6 [PR-CM] Kings Forest Stage 1 Project Application and Amendment 2 to the Concept Plan - Council's Submission to the NSW Department of Planning and Infrastructure

This report serves two purposes. The first is to provide Councillors with a brief summary of the current proposal and the second is to provide an assessment of the application (primarily with regard to matters affecting Tweed Shire Council from an asset and infrastructure ownership perspective). This assessment is intended to be forwarded to the NSW Department of Planning and Infrastructure and form Council's official response to this application.

That Council endorses this report to form the basis of a submission to the NSW Department of Planning and Infrastructure in respect to the Stage 1 Project Application for Kings Forest.

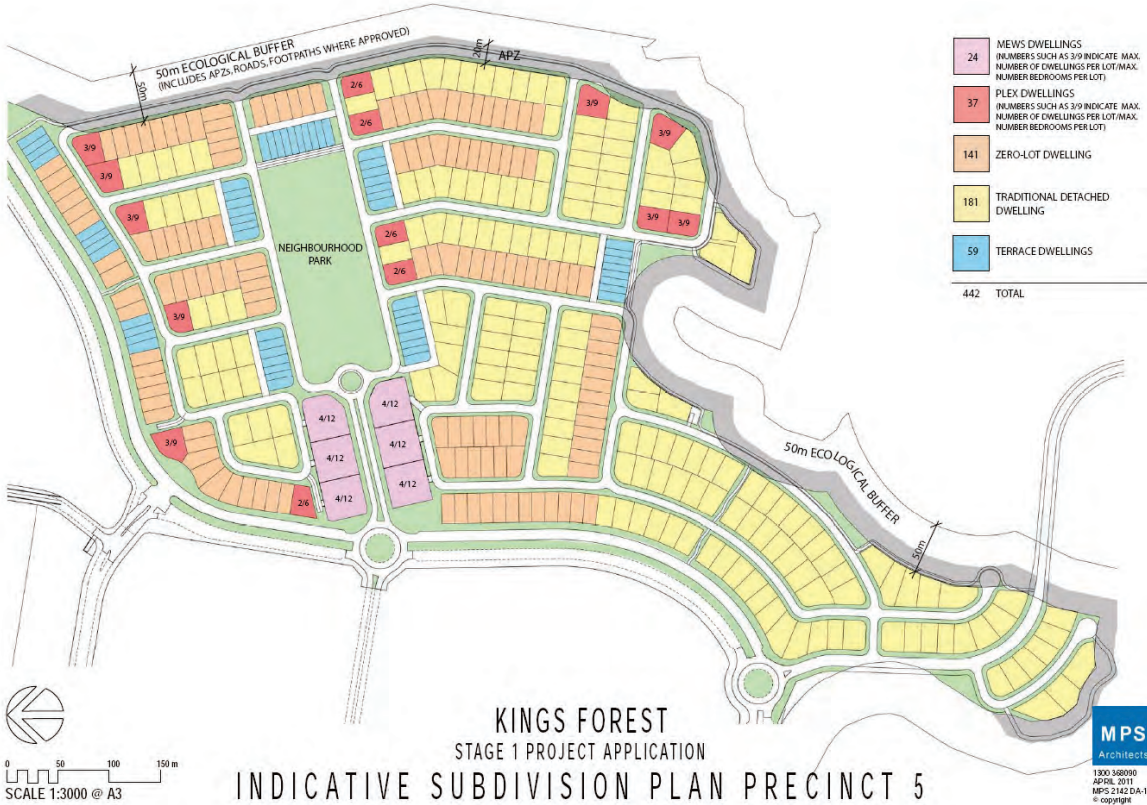
- The Plans of Development for Precinct 5 (Appendix H Plan of Development Detail 1, 2 and 3) should be modified as follows in order to clearly depict future vehicle access and servicing to each allotment:

KINGS FOREST
STAGE 1 PROJECT APPLICATION
INDICATIVE SUBDIVISION PLAN PRECINCT 5

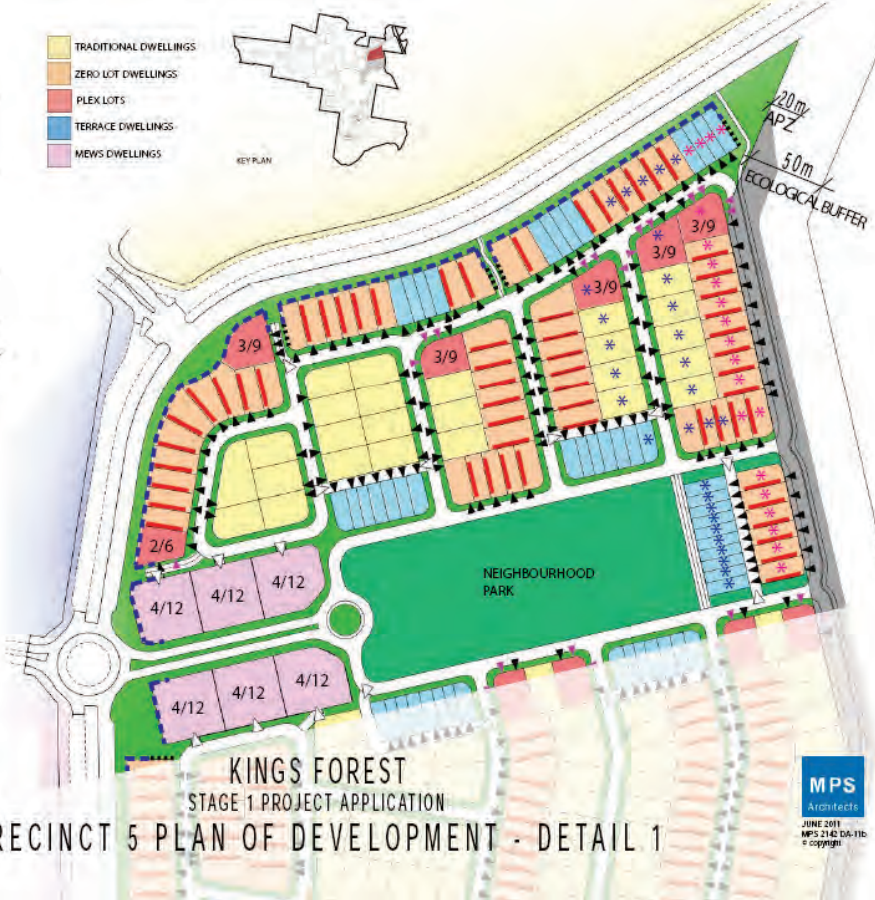
The Precinct 5 Plan of Development Detail 1, 2 & 3 (Appendix H) refers to the Kings Forest Development Code for minimum rainwater tanks sizes. The Development Code however is silent on mandating rainwater tanks for complying development but does require it in Section 3.1.8. (Note: Subdivisions 31 and 32 provide for the installation of rainwater tanks as exempt development.) despite having Appendix C "Council's Rainwater Harvesting Requirements." The Design Guidelines (Appendix P) say "Ensure the house design allows the majority of the roof water to be directed to the rainwater tank/s" as well as providing some conditions about screening, colour and use of underground tanks. There is nothing that actually mandates installation of rainwater tanks for complying development or more than 51% of the roof area to be drained to a tank. Council has adopted a Demand Management Strategy that identified a minimum size rain water tank connected to a minimum roof area as reflected in the table in the Development Code, Appendix C.

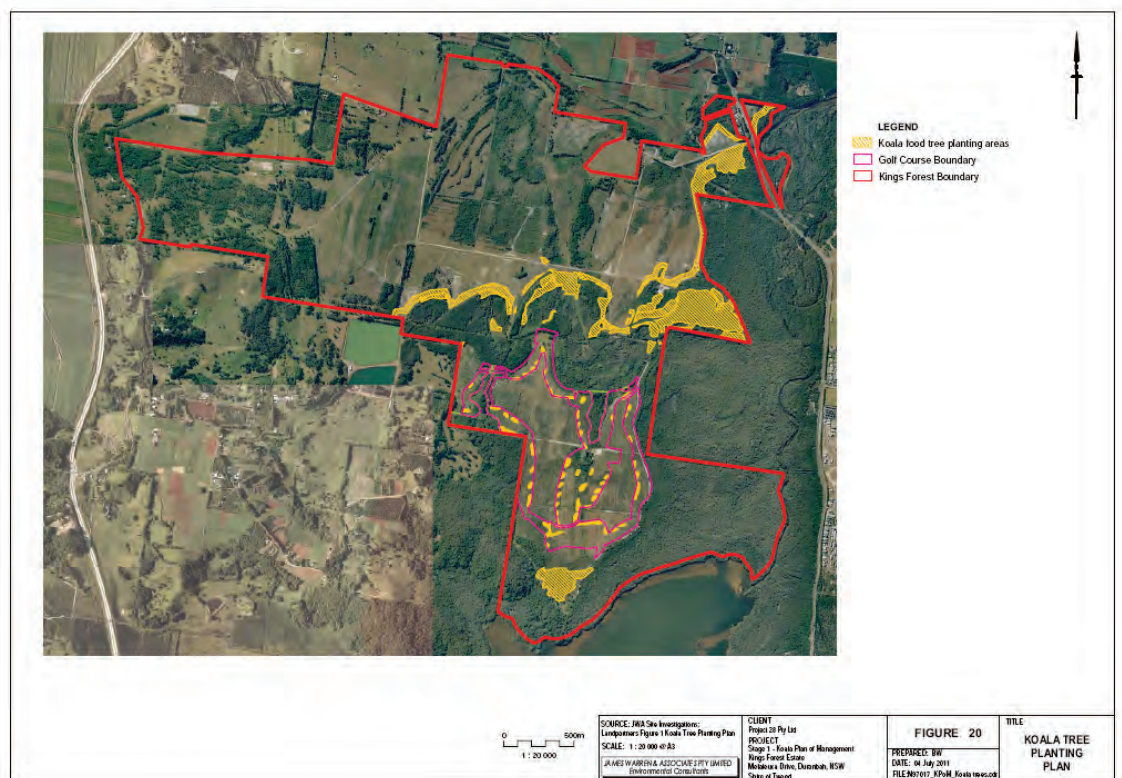
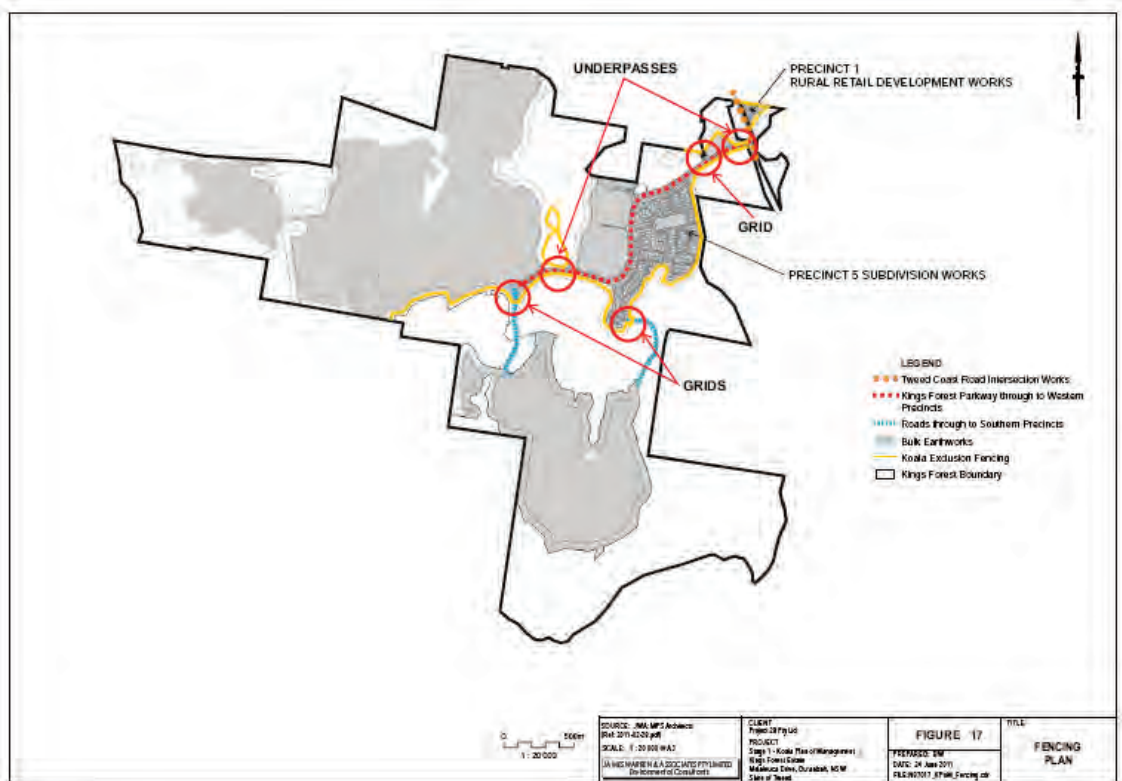
- The proposed fencing plan (Figure 17 of KPOM) does not “seal off” Precinct 5, potentially allowing koalas to access to roads from the north of the estate. This could be achieved by extending the fencing along the western boundary of Precinct 4, around the western and northern boundary of the Council sports fields (under construction) then around the ecological buffer at the north of Precinct 3 to link to the proposed fencing shown in Figure 17 of the revised KPOM. Proposed fencing to the south east of Precinct 7 (i.e. north of the proposed Kings Forest Parkway) is not considered necessary or desirable at this stage. Further fencing along the eastern boundaries of Precincts 7 and 8 should be included in the project applications for those stages.

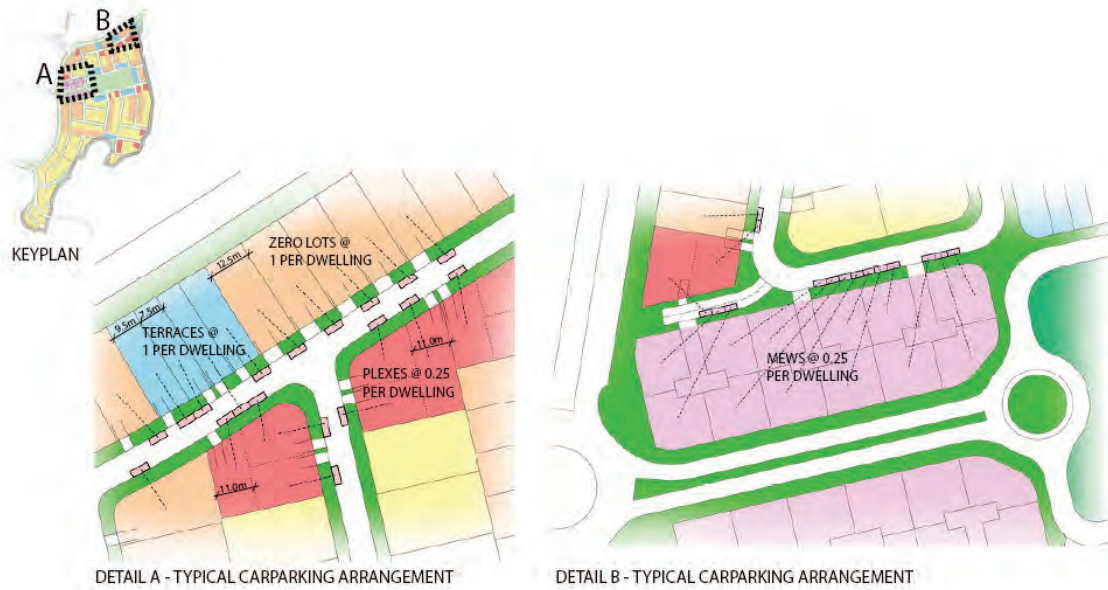
The application has only been accompanied with indicative on street parking plans as duplicated below:
